TO: Rob Young, PE Project Manager Vermont Agency of Transportation	DATE	PROJECT NO.
	12/2/2015	Woodstock BRF 0151 (21)

COPIES	NUMBER	DESCRIPTION	CODE
1		Bridge Rail Sheets 1 - 4	H
1		Bridge Rail WPS 3008 & 3009	H
1		Rail Transitions Sheets 1 - 5	H
1		Rail WPS 3007, 3009, 3016, & 3022	H

BRIDGE RAIL DETAILS SHEET
 VERMONT ROUTE 106 (MAJOR COLLECTOR, RURAL), BRIDGE # 24
 TOWN OF WOODSTOCK, COUNTY OF WINDSOR, VT.

SHEET 2 OF 5

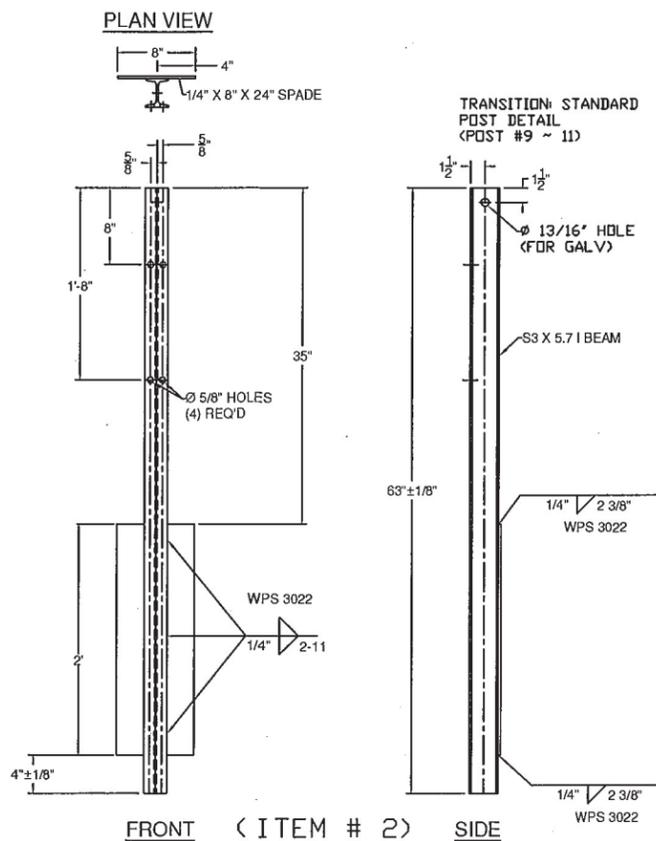
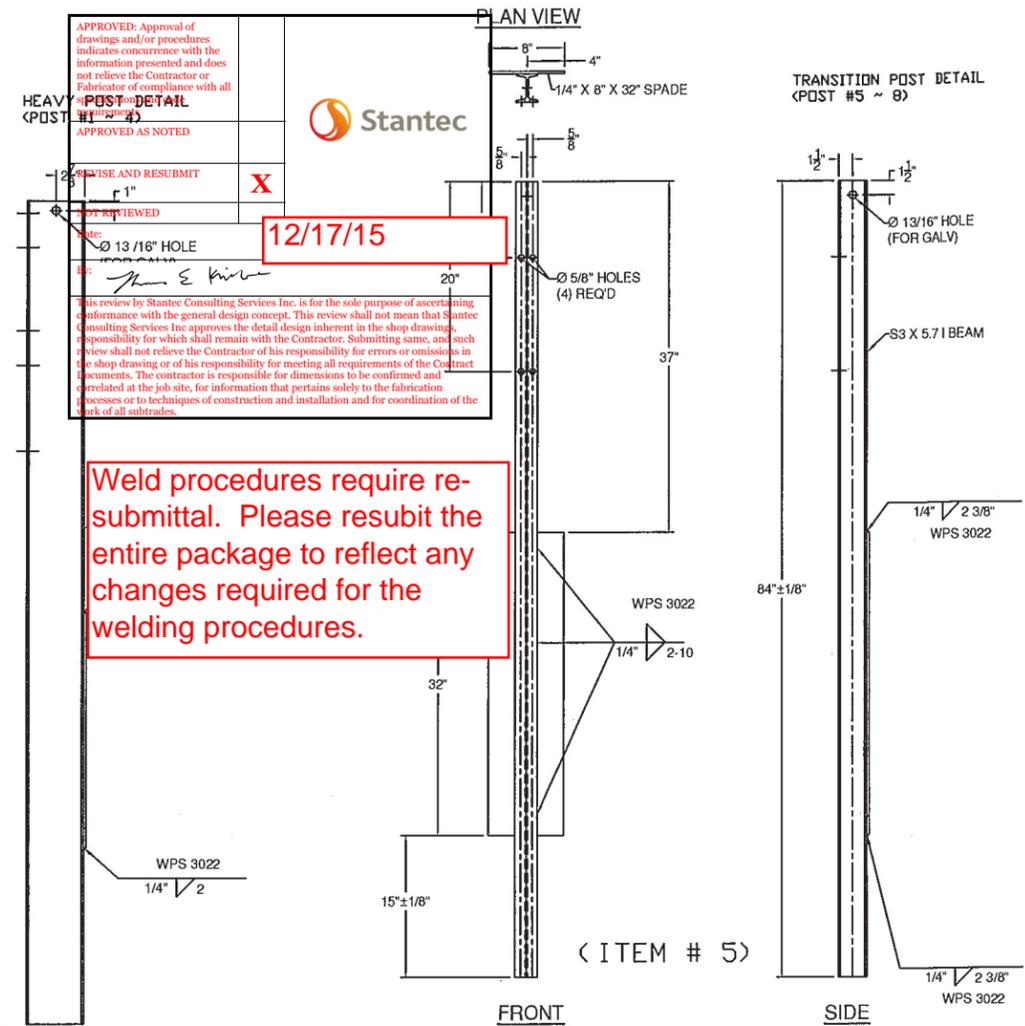
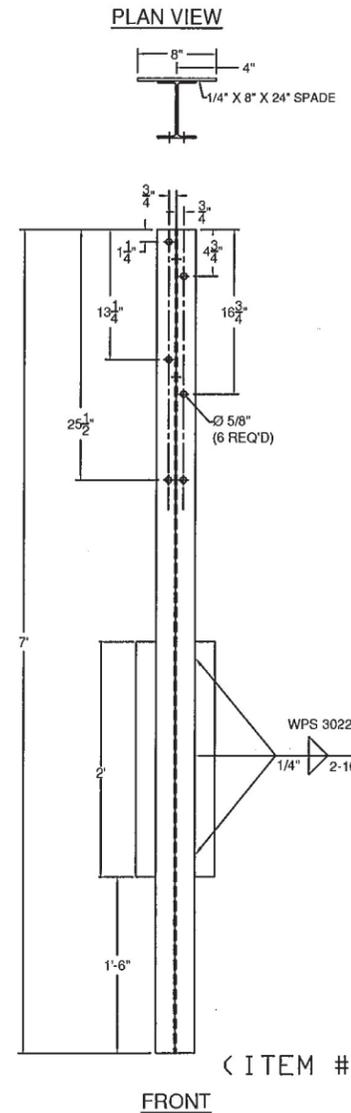
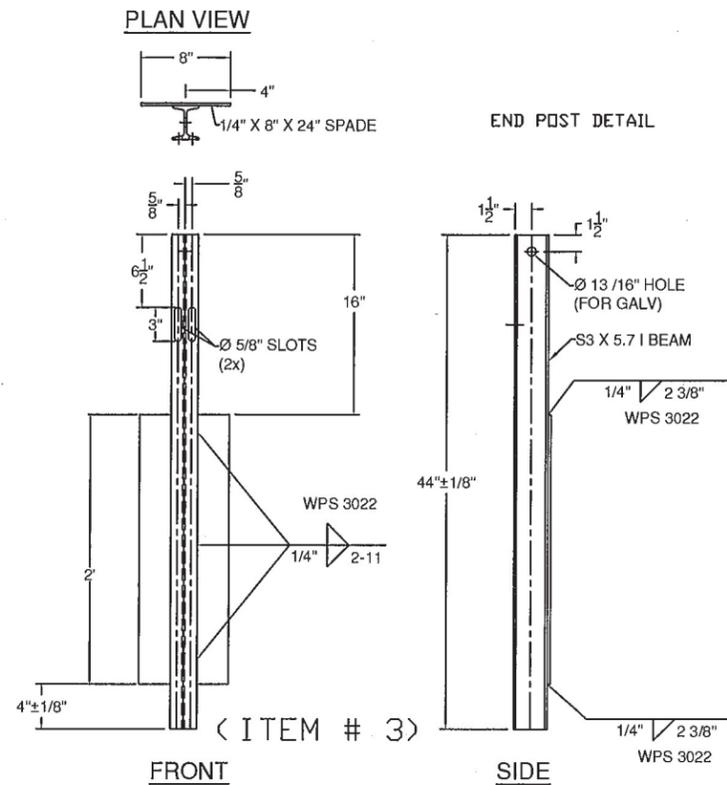
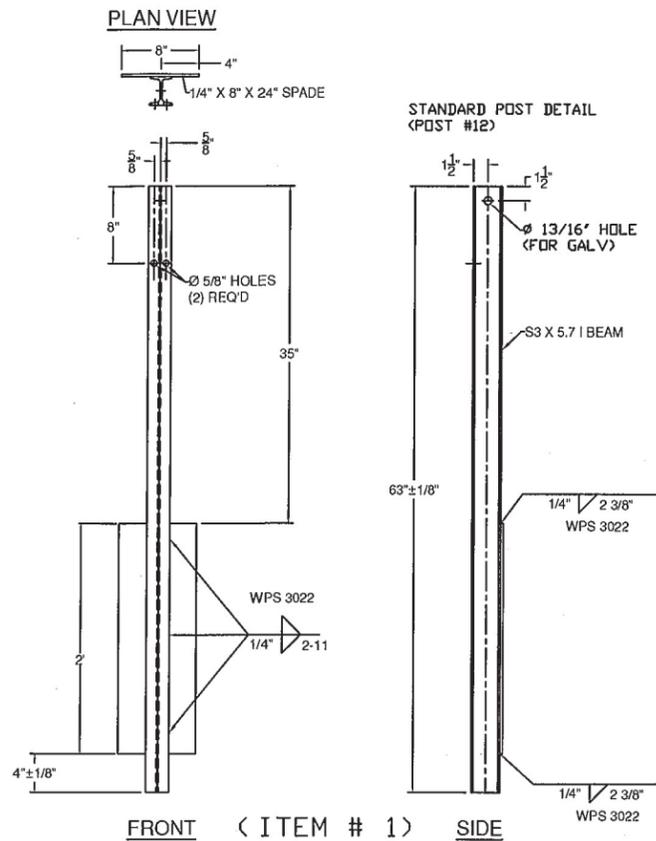
Weld procedures require re-submittal. Please resubmit the entire package to reflect any changes required for the welding procedures.

SHEET 4 OF 5

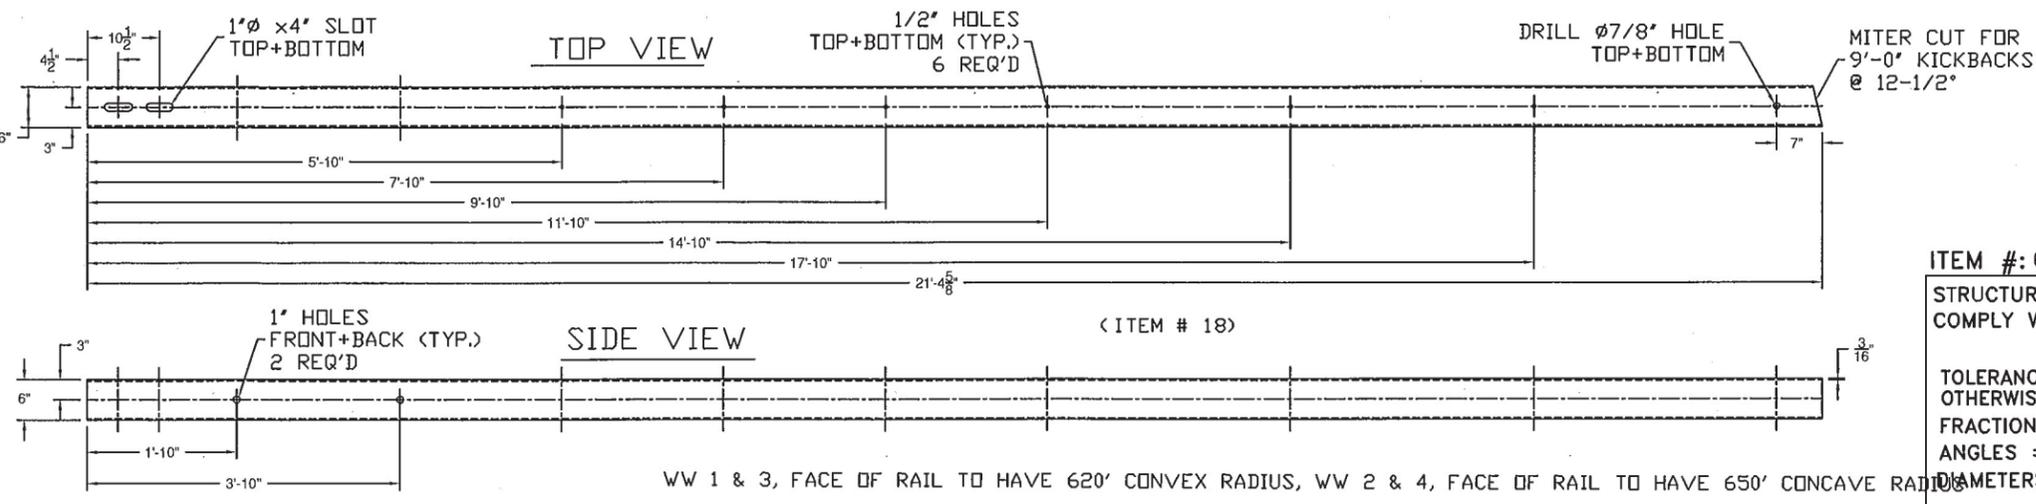
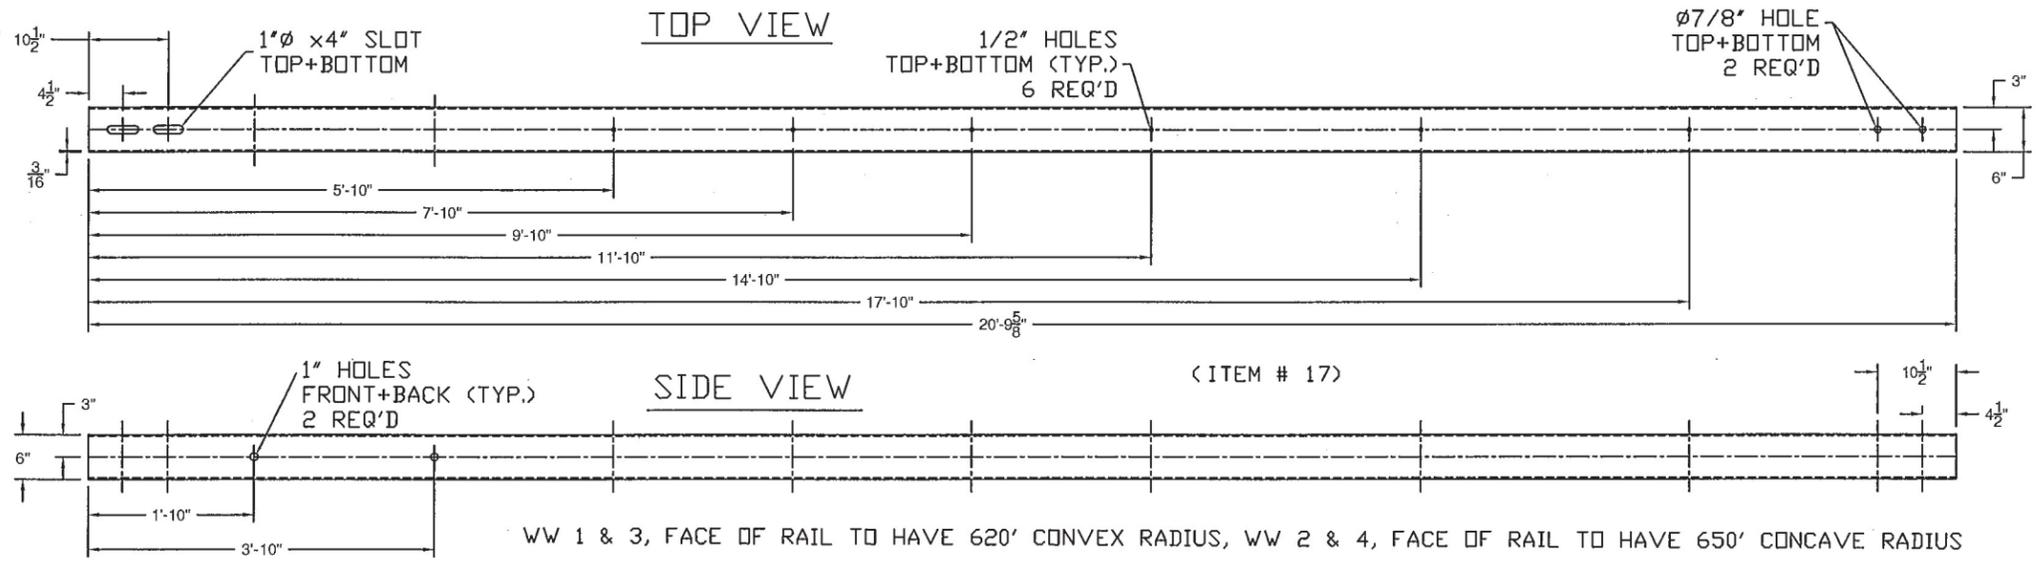
Weld procedures require re-submittal. Please resubmit the entire package to reflect any changes required for the welding procedures.

SHEET 5 OF 5

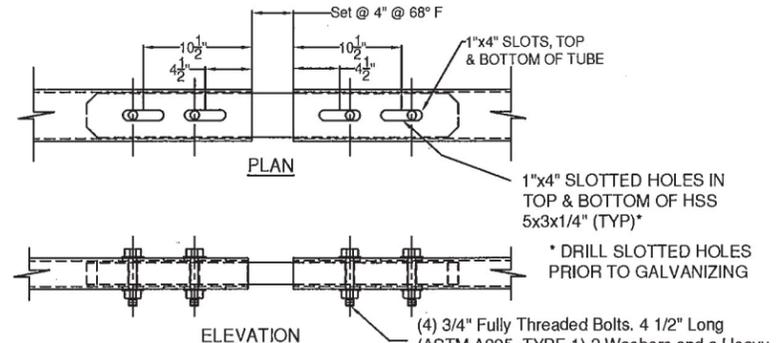
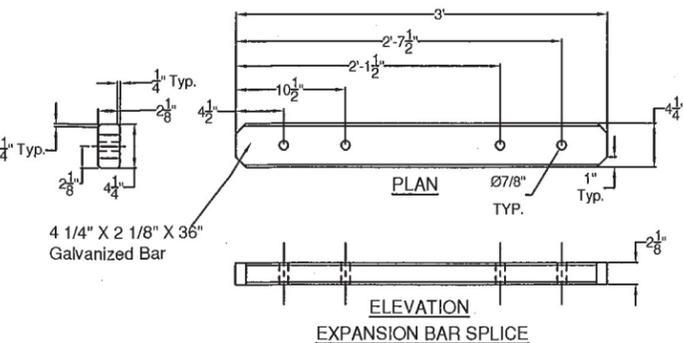
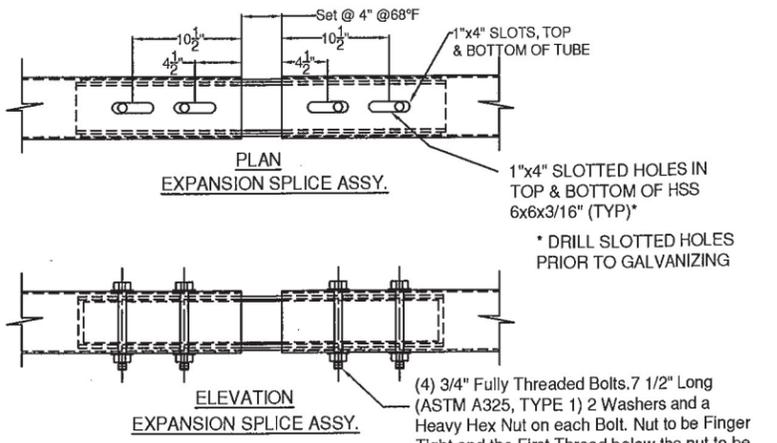
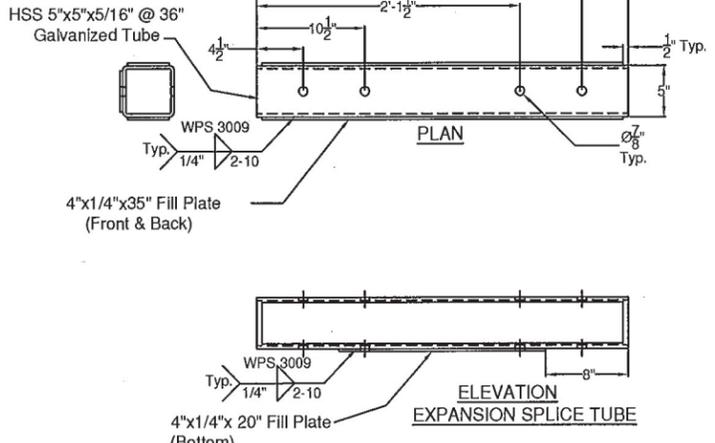
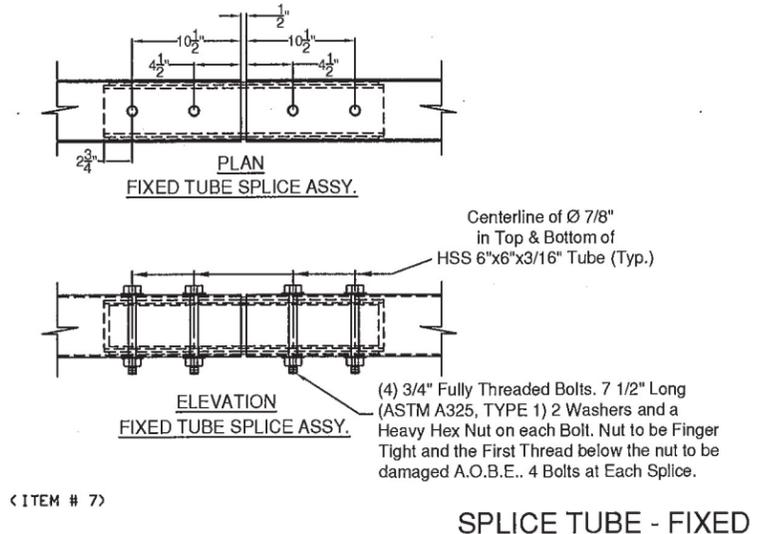
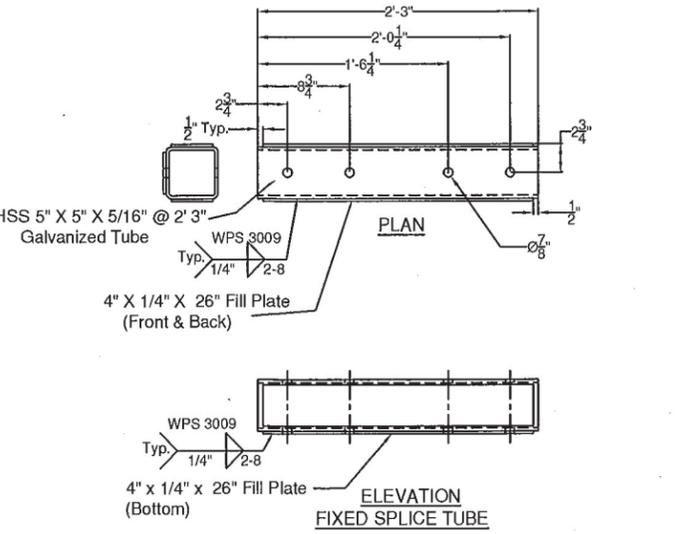
Weld procedures require re-submittal. Please resubmit the entire package to reflect any changes required for the welding procedures.

Procedure No. 3007

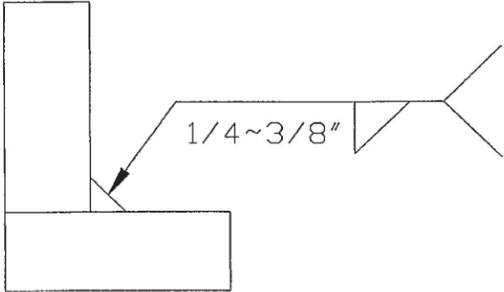
Is this a NY joint detail?
